INTERNAL CORRESPONDENCE

SUBJECT: ECO Matrix and rework for IPB, IOC, DRR Boards REV 3

This document contains the rework required to up-grade the IOC, IPB, DRR Channel and interface boards to the latest correct dash and REV level.

FIGURE 1

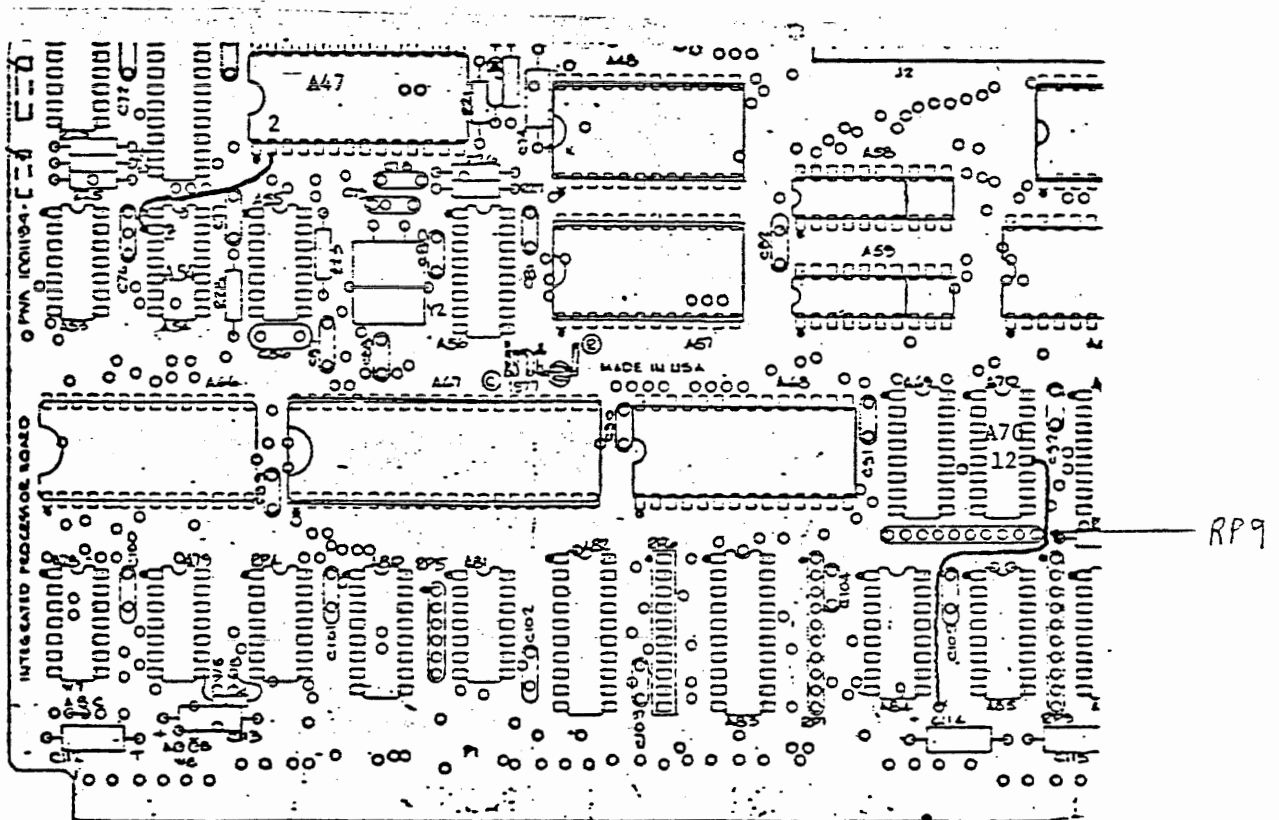
1. Replace IC 101502-001 in location A70 with IC 102899-001.
2. Remove A54 pin 2 from pad on the board and bend lead straight out from body of IC

3. On solder side, cut the trace running from RP9-3 to the feed thru located near A84-9. (See figure 1).

4. On component side, install a jumper from the feed thru located below and to the right of A84-9 to A70-12.
5. On component side, install a jumper from the lead of A54-2 to A47-2.

ECO 2-4556A

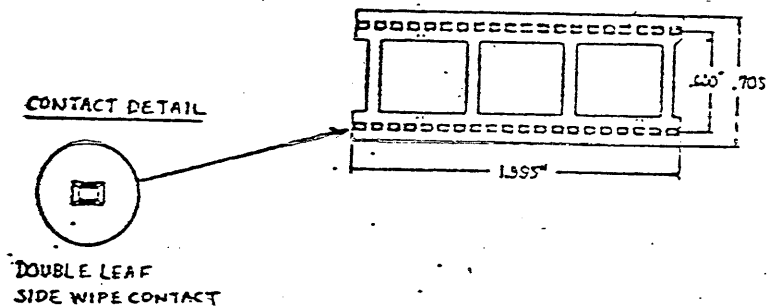
1. Remove the 8080 at location A67.
2. Inspect the 40 pin socket for the type shown below:

The 40-pin sockets to be replaced are Intel P/N 101555-040 (typical example shown below):

3. If PWA does have the above sockets, remove all 40-pin sockets shown above.
If PWA does not have this type of socket, replace IC's in sockets (socket is then of the right type).
4. Replace 40-pin socket with Scanbe or Augat type socket (P/N 101581-040 or 102989-001).
5. Replace IC into socket.

ECO 1945

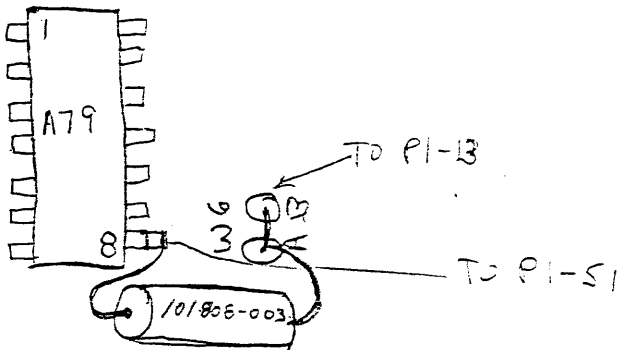
Add .22 uh choke to clock service line

1. Clip pin A79-8 flush with PCB and bend up pin.
2. Solder choke .22 uh (101808-003) from A79-8 to adjacent jumper wire as shown in below.

FIGURE 1

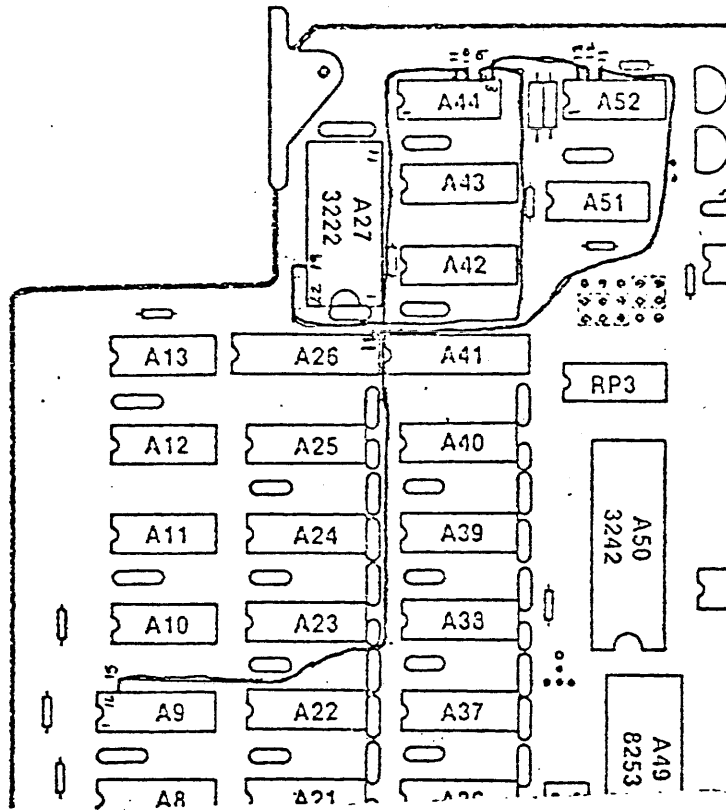
1. Replace all 74S74 (100913-001) with 74LS74 (100914-001)
2. Cut trace from A9-15 to A26-11
3. Add jumpers as follows, (see figure 1):

<u>FROM</u>	<u>TO</u>
A27-19	A44-9
A9-15	A44-10 & 11
A44-8	A52-12 & 13
A52-11	A26-11

ROUTING FOR ECO 2210

20 BIT ADDRESS PIGGY-BACK BOARD

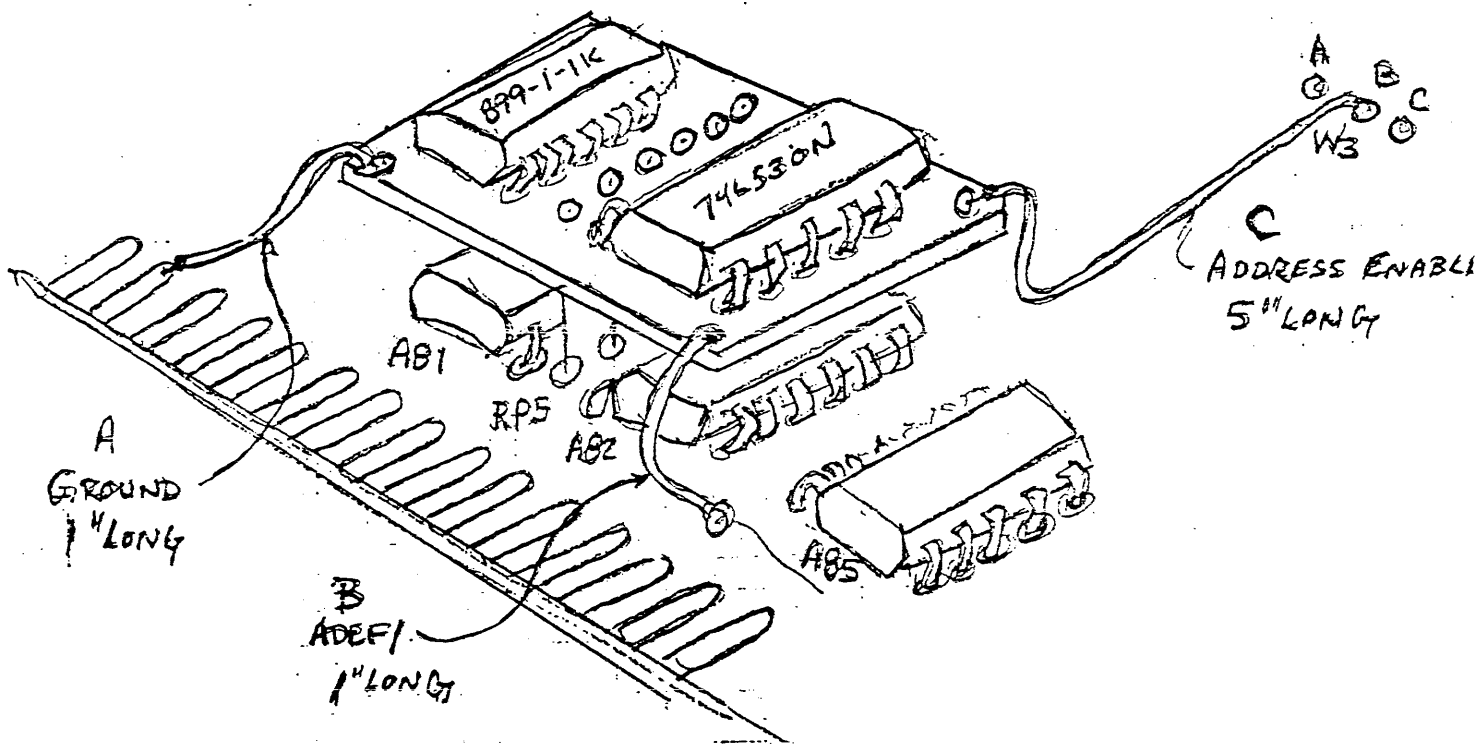
P/N 1002234-01

1. Remove RP5, A SIP resistor package
2. Fit prongs of piggy-back board into holes of RP5 and solder
3. Solder Jumper A to ground
4. Solder Jumper B to ADRF/ at feed through
5. Solder Jumper C to jumper feed through W3-B

ECO 2-4565

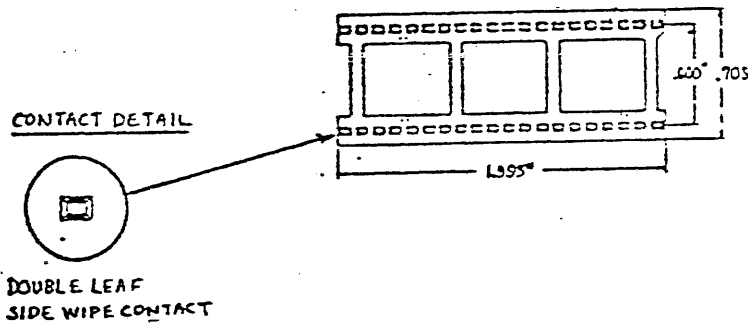
1. Remove 40 pin IC's at locations A1, A20, A58, A69 and A72.
2. Inspect 40 pin sockets for the type shown below:
The 40-pin sockets to be replaced are Intel P/N 68-234 (typical example shown below)

3. If PWA does not have this type of socket, replace IC's in sockets (sockets are then of the right type).
4. If PWA does have the above sockets, remove all 40-pin sockets shown above.
5. Replace 40-pin sockets with Scanbe or Augat type (P/N 102989-00 or 101581-040)
6. Replace IC's in sockets

ECO 2-3629

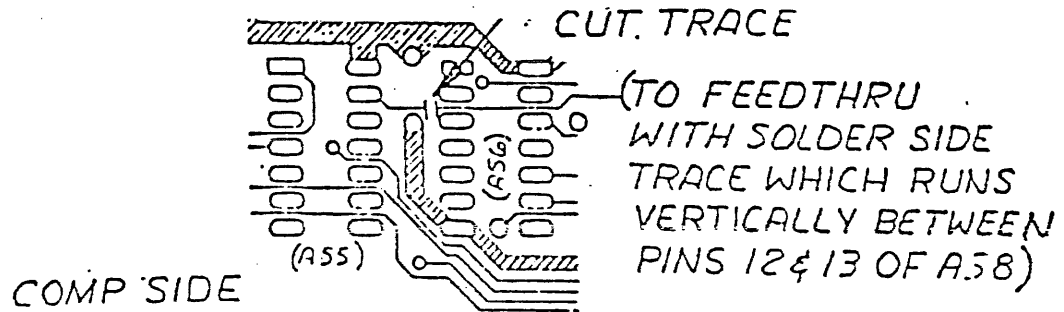
1. Cut trace running to A55-13, from feed thru

2. Add jumper wire from feed thru just cut to A56-2
3. Add jumper from A72-7 to A72-20 (GND)

ECO 2-5304

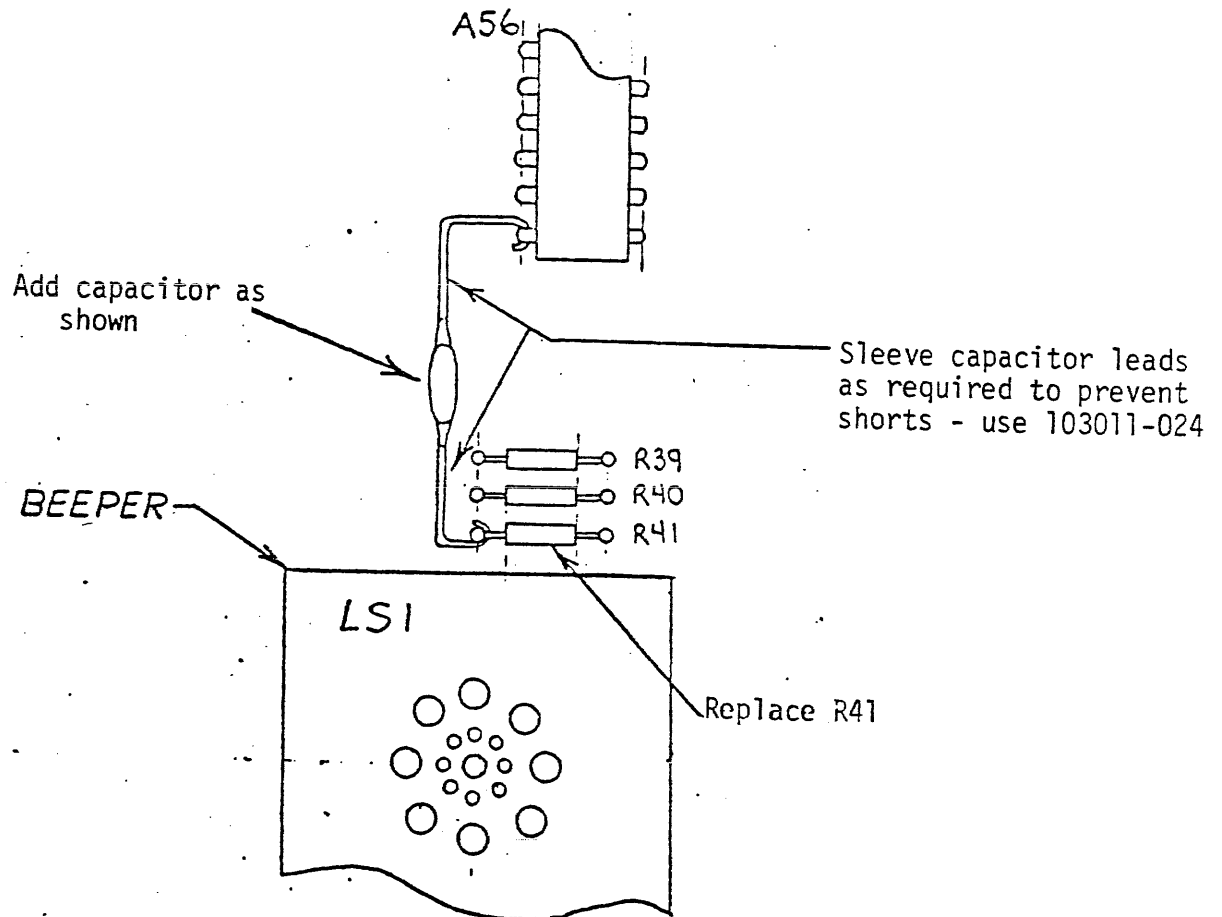
1. Remove resistor R41 (1K 5% $\frac{1}{4}W$) and replace with:
(1ea) 101656-06Z resistor 750 $\frac{1}{4}W$ 5%.
2. Add (1ea) capacitor P/N 101754-049, CER. 0.1 UF 50V. Between A56-7 (gnd)
and R41, per sketch below. (Sleeve leads as shown)

ECO 2-2699A

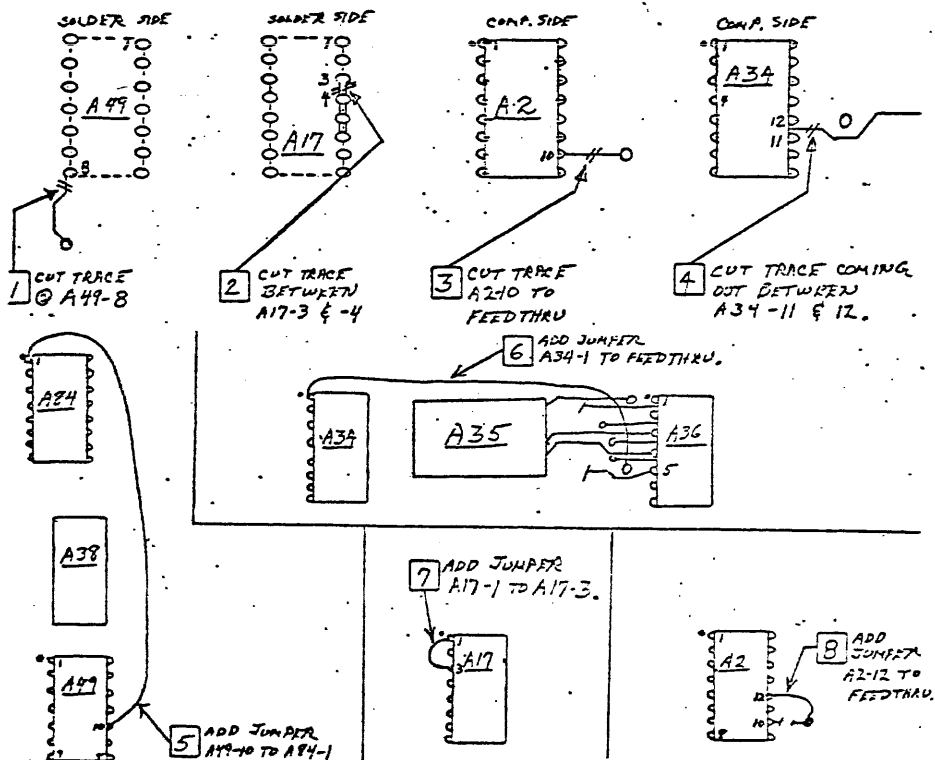
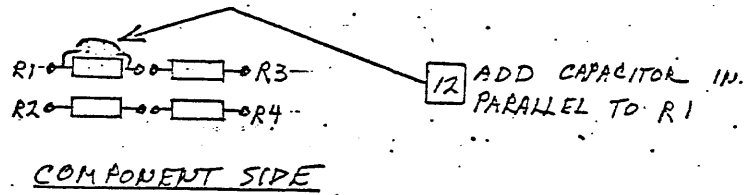
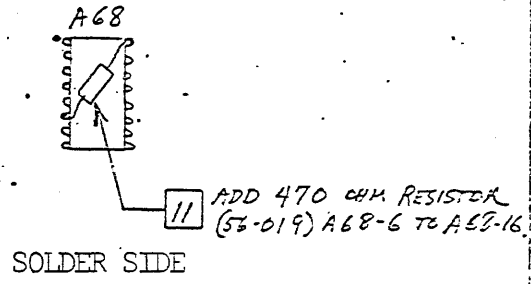
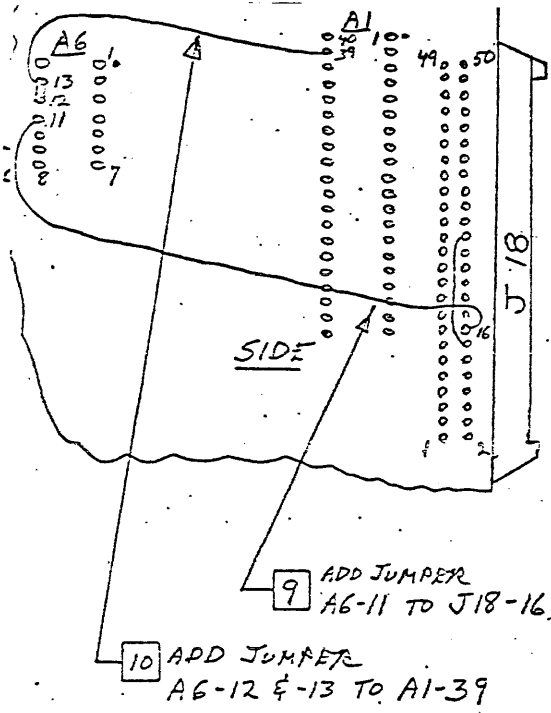
1. Cut trace (solder side) at A49-8.
2. Cut trace (solder side) between A17-3 and A17-4.
3. Cut trace (component side) A2-10 to feed through.
4. Cut trace emerging from under A34 (comp. side) between pins.
5. Add jumper from A49-10 to A84-1 (component side)
6. Add jumper from A34-1 to feed through adjacent to A36-5 (component side)
7. Add jumper from A17-1 to A17-3 (component side)
8. Add jumper from feed through adjacent to A2-10 to A2-12 (component side)
9. Add jumper from A6-11 to J18-16 (solder side)
10. Add jumper from A6-12 & 13 to A1-39 (solder side)
11. Add (1 ea.) 470 Ω resistor (P/N 101656-022) from A68-6 to A68-16 (component side)
12. Add capacitor C-90 in parallel to resistor R1. P/N 101766-037 CAP. CER, .01 μ F +80, -20% 25V.

ECO 2-3774

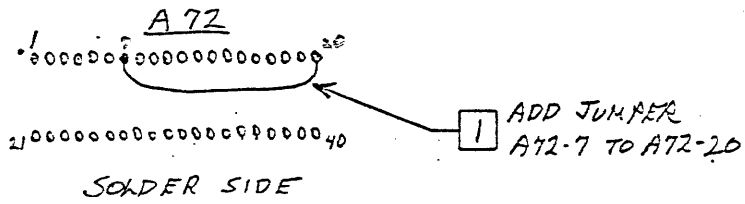
1. Add jumper from A72-7 to A72-20 (gnd) or equivalent

ECO 2-4578

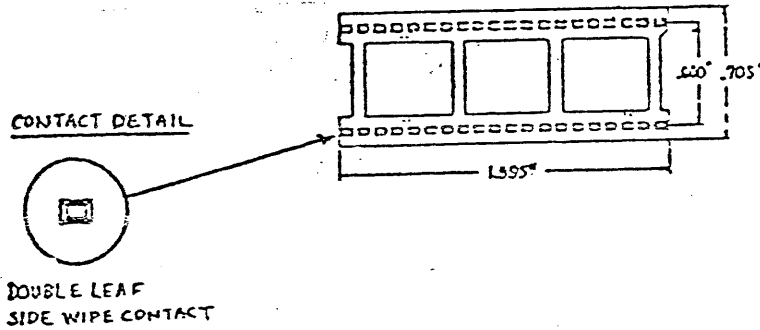
1. Remove 40 pin IC's at locations A1 (8271), A20 (8275), A58 (8257), A69 (8080A-2), and A72 (8741-4).
2. Inspect 40 pin sockets for the type shown below:

If PWA does not have this type of socket, replace IC's in sockets (sockets are the correct type).

3. If PWA does have the above sockets, remove all 40-pin sockets shown above.
4. Replace 40 pin sockets with Intel P/N 102989-001.
5. Replace IC's in sockets.

FIGURE 1

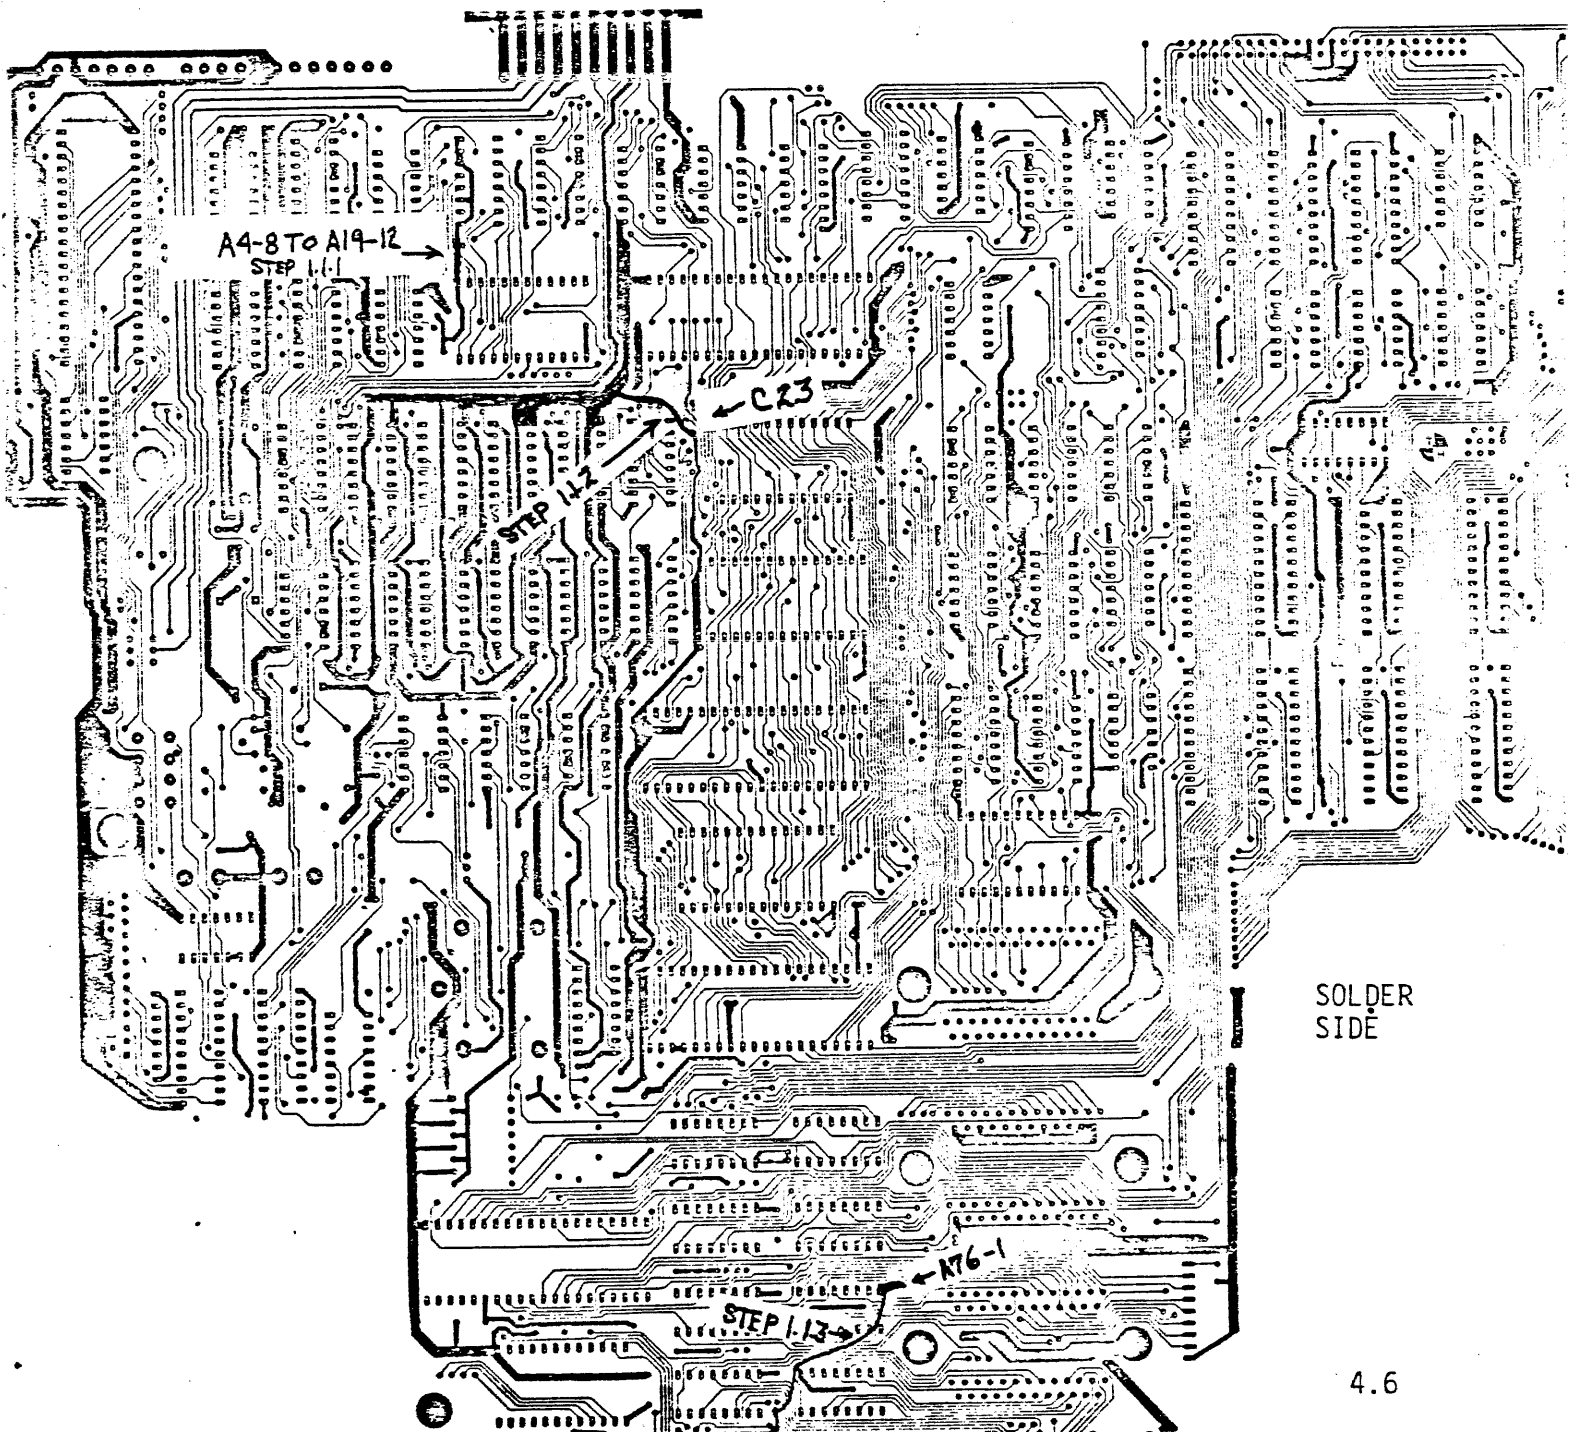
1. Add 12 jumpers using 20AWG green stranded wire per the following:

1.1.1 From A4-8 to A19-12 (gnd)

1.1.2 From feedthru in gnd bus between A33-16 and A6-7 to lead of C23 adjacent to A34-15.

1.1.3 From feedthru adjacent to C87 and A78-16 to A76-1.
